RE: **Lot 21 Block 1 Unit 27 SAD 228**  
**5505 Valiente Rd. NW**  
**Volcano Cliffs Subdivision**  
**Grading and Drainage Plan**  
**Engineers Stamp Date 5/19/2023 (C11D009)**

Based upon the information provided in your submittal received 6/20/2023, this plan is approved for Grading Permit.

Grading and Drainage Plan

5505 Valiente Rd. NW  
Lot #21, Block 1, Volcano Cliffs, Unit 27

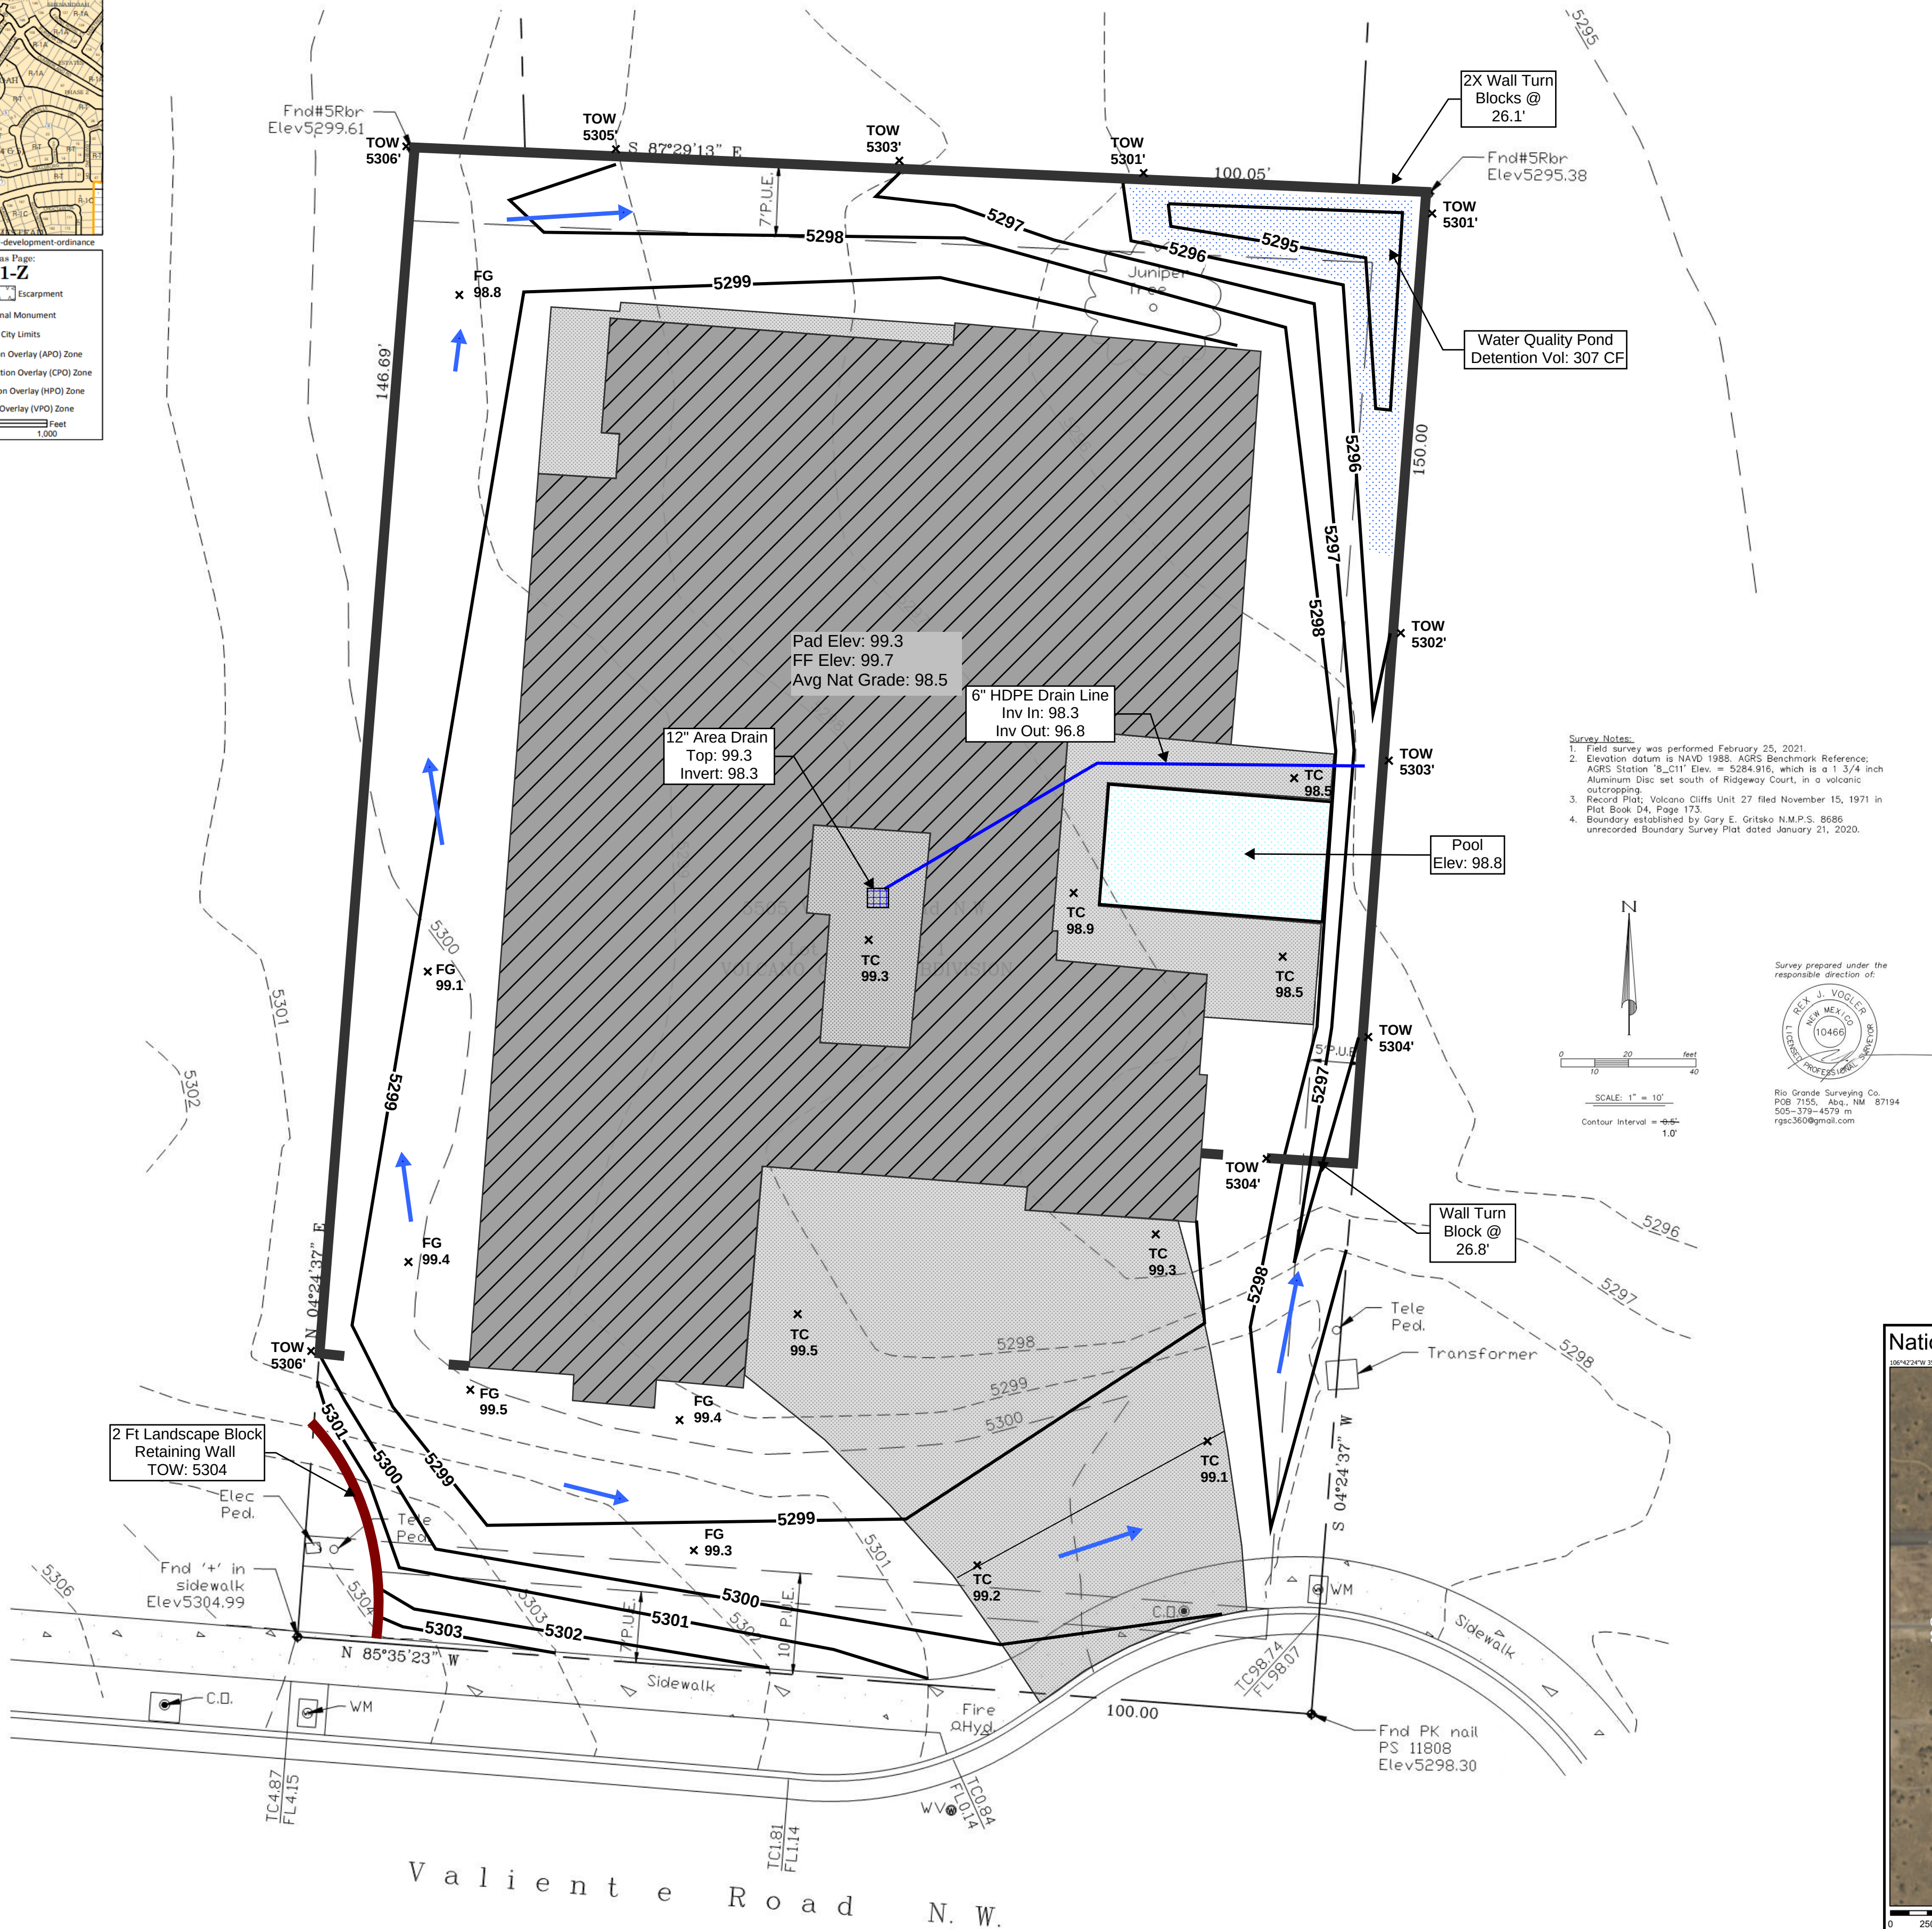
**Prior to Building permit approval a Pad Certification will be required, provided by the Engineer or a registered Land Surveyor.**

**Advise the owner contractor not to use dirt as a ramp to climb the curb, use lumber or crusher fines for this purpose. Place this note on the plan.**

**Reiterate to the Owner/Contractor that a separate permit for a garden/retaining wall must be obtained with the approved G&D plan and Pad Certification. Also, if a swimming pool is to be placed after this approval a new grading and drainage plan will need to be resubmitted showing the changes for the land treatments.**

**Prior to Certificate of Occupancy release, Engineer Certification per the DPM checklist is required.**
